GAHANNA BRANCH LIBRARY

ADDITION FOR COLUMBUS METROPOLITAN LIBRARY

PROJECT NUMBER: 96M122

POWER PLAN

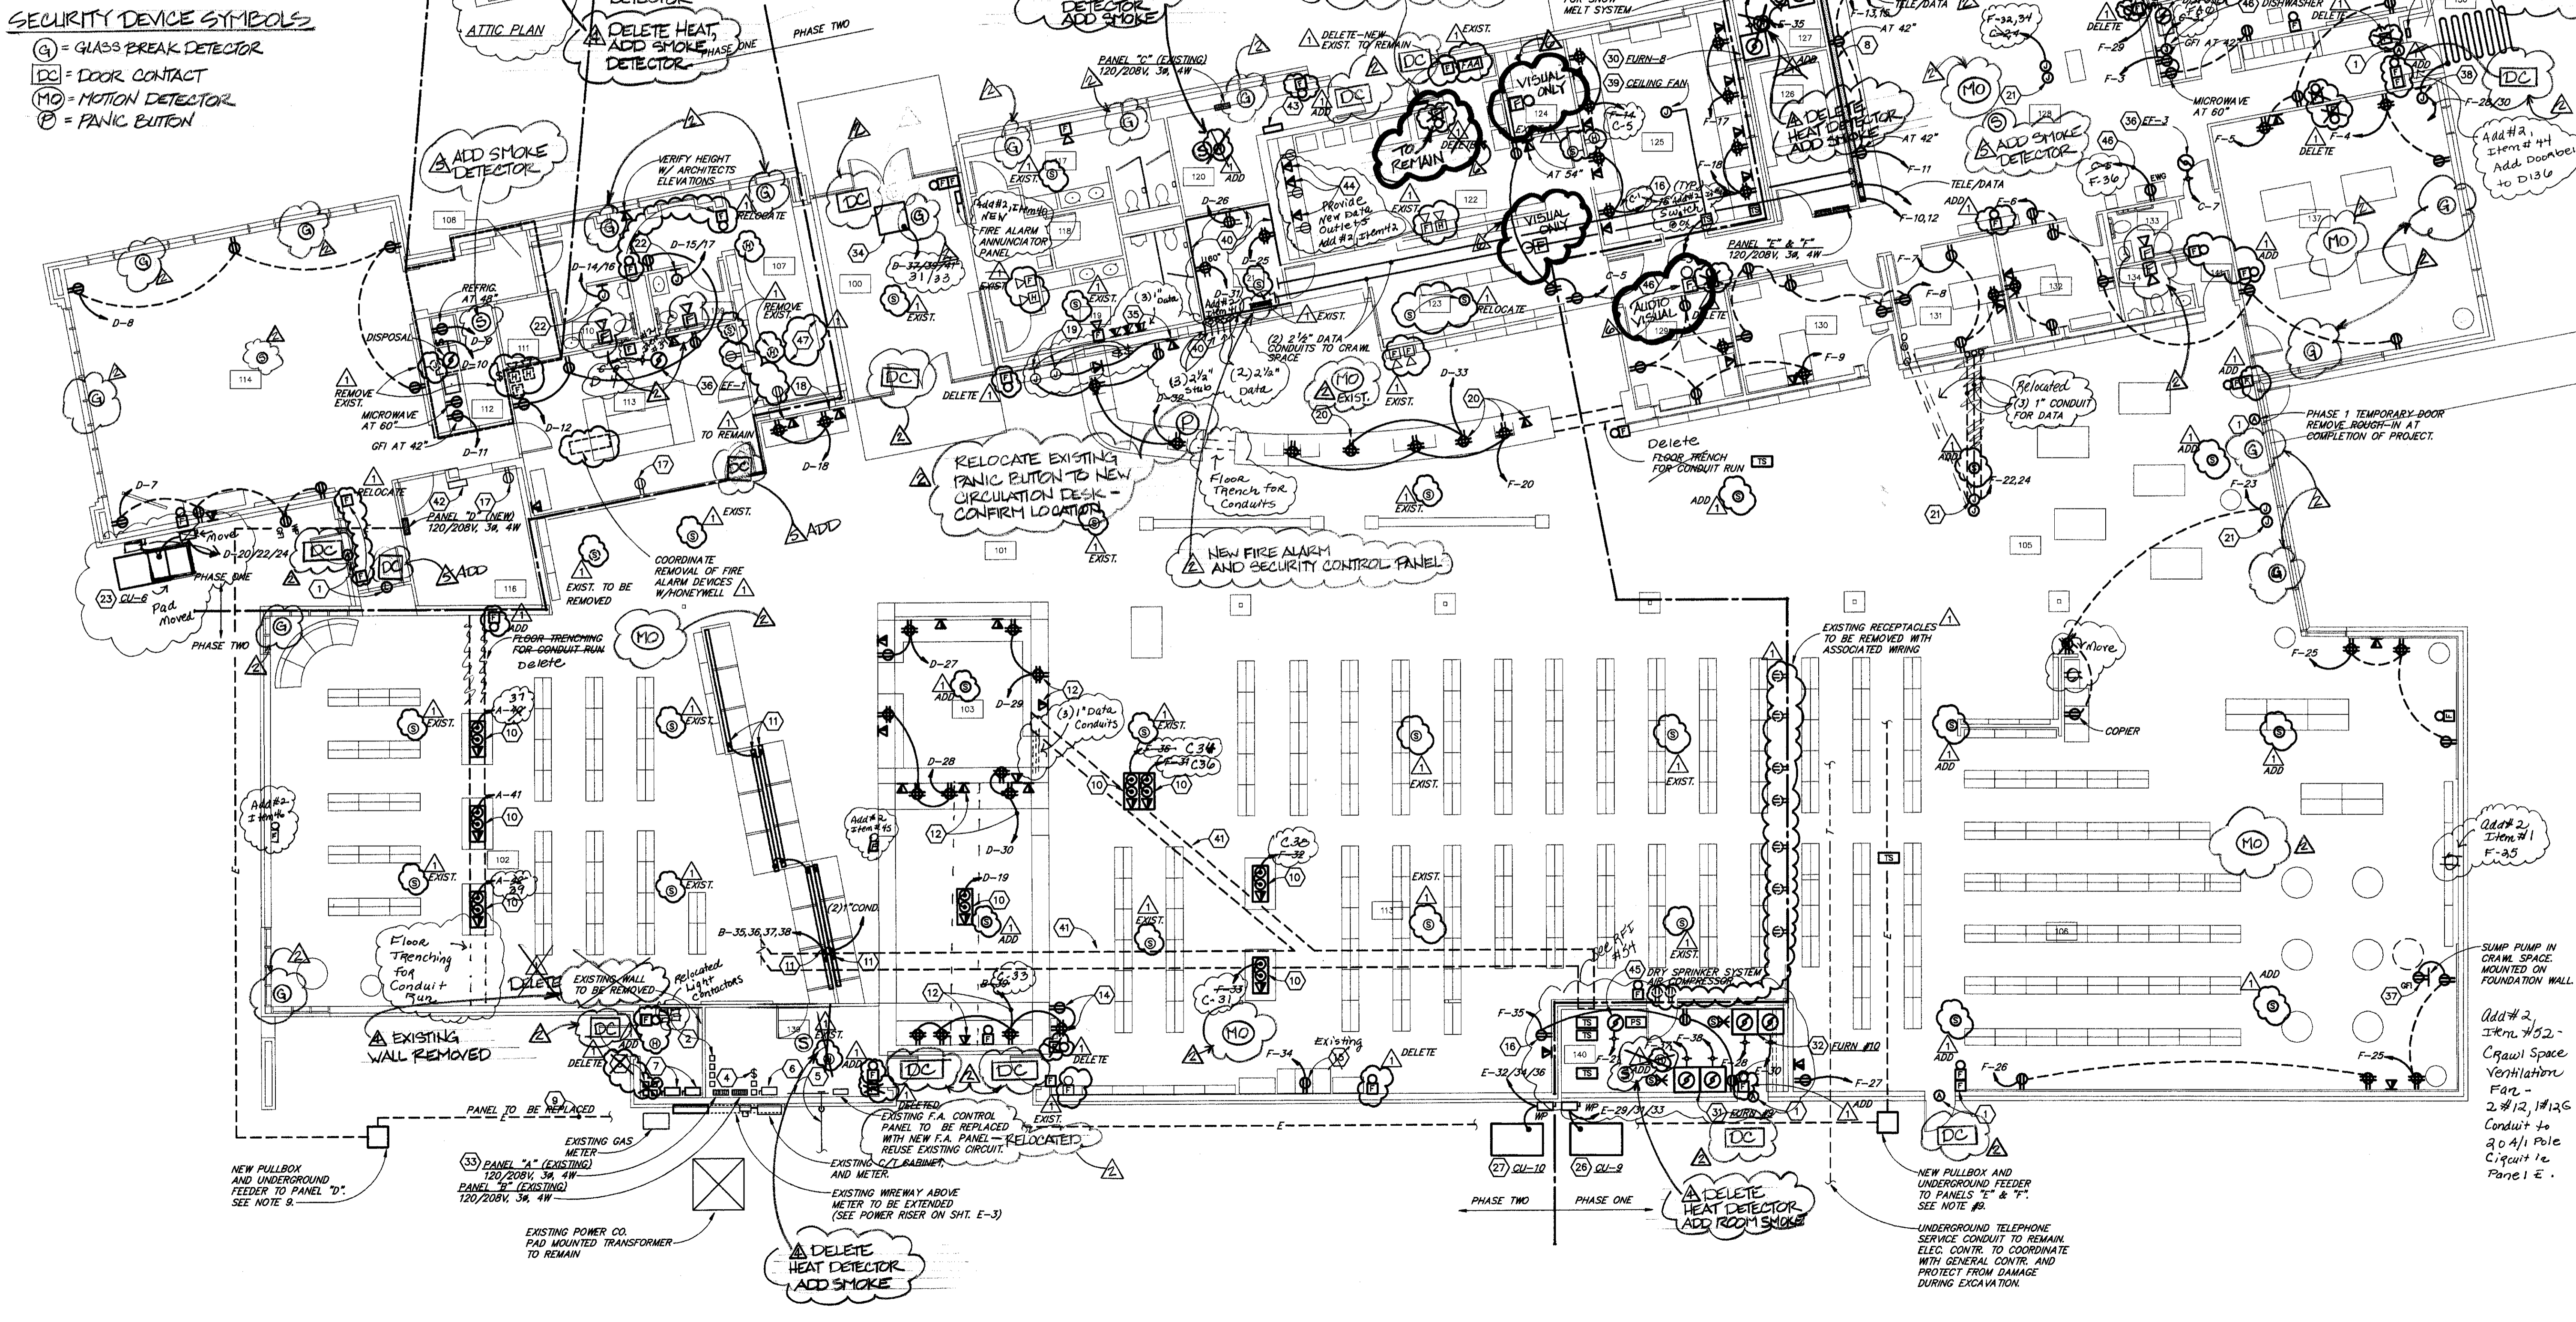
- RECEPTACLE FOR 120 VOLT CHANGE DISPENSER. PROVIDE SURFACE MOUNTED WIREMOLD TO ABOVE CEILING AND VERIFY MOUNTING HEIGHT. Add #2, Item #17.
- RECEPTACLE FOR 120 VOLT COPIER. CUT AND PATCH WALL AS REQUIRED TO INSTALL ROUGH-IN AND CONDUIT.

- ROUTE CONDUITS FOR POWER AND DATA IN FLOOR FROM CIRCULATION DESK TO WALL THEN TO ABOVE CEILING. PROVIDE RECEPTACLES IN CIRCULATION DESK AND 120 VOLT CIRCUITS AS SHOWN. PROVIDE 1" DATA CONDUIT TO ABOVE CEILING. Add #2, Item #18.

- ADD #2, Item #14. JUNCTION BOX IN CRAWL SPACE FOR 208V 1/4 SNOW MELTING. PROVIDE TEMPERATURE SENSORS, PRECIPITATION SENSORS, CONTACTORS, SNOW MELTING CABLE WIRING AND CONDUIT REQUIRED TO PROTECT CONCRETE WALK AND STEPS. VERIFY AREA OF WALK AND QUANTITY STEPS WITH ARCHITECTURAL DRAWINGS. RUN 2 #10 & #10 GRD IN 3/4" CONDUIT FROM JUNCTION BOX TO 20A-1P BREAKER IN PANEL. SYSTEM BY Toucher. Model #EMA-18. S.E. 11/10/11. S.D. 11/10/11. V.P. 11/10/11. E.M. 11/10/11.

- PROVIDE 3/4" PLYWOOD WITH FIRE RETARDED PAINT, ON WALL FROM FLOOR TO CEILING. COORDINATE WITH LIGHT SWITCH, RECEPTACLES, DATA OUTLETS IN THIS ROOM. COORDINATE WITH THE OWNER ON EXISTING ROUGH-INS & EQUIPMENT. PROVIDE (3) 2 1/2" CONDUIT sleeves to E wall above ceiling. Add #2, Item #14.

- 7" TRENCH PROVIDE BY GENERAL CONTRACTOR. COORDINATE EXACT LOCATION WITH ARCHITECT AND OWNER. CUT-OUT TO ACCEPT PULL BOXES WHERE NECESSARY. Add #2, Item #50.

- (ALTERNATE) EXISTING IRRIGATION SYSTEM CONTROL PANEL TO BE RELOCATED TO ROOM 120 BY OTHERS. E.C. TO DISCONNECT.
- (ALTERNATE) RELOCATED IRRIGATION SYSTEM CONTROL PANEL (APPROX. LOCATION). E.C. TO EXTEND FEEDER FROM AVAILABLE POWER SOURCE IN THIS ROOM. FIELD VERIFY EXACT LOCATION PRIOR TO INSTALLING CONDUIT TO PANEL. P. BY E.C., Q.1 OTHER WIRING BY IRRIGATION SYSTEMS ON L-5. Add #2, Item #53.

See RFI #10-16
#19, #21, #22
#40, #41
#53: Grounding
#60 -> 63
S.O.S. 1/10/15
#66 - Room #140

Add #2, Item #52 - Crawl Space Ventilation Fan - 2 #12, 1 #12G Conduit to 20A/1 Pole Circuit in Panel E.
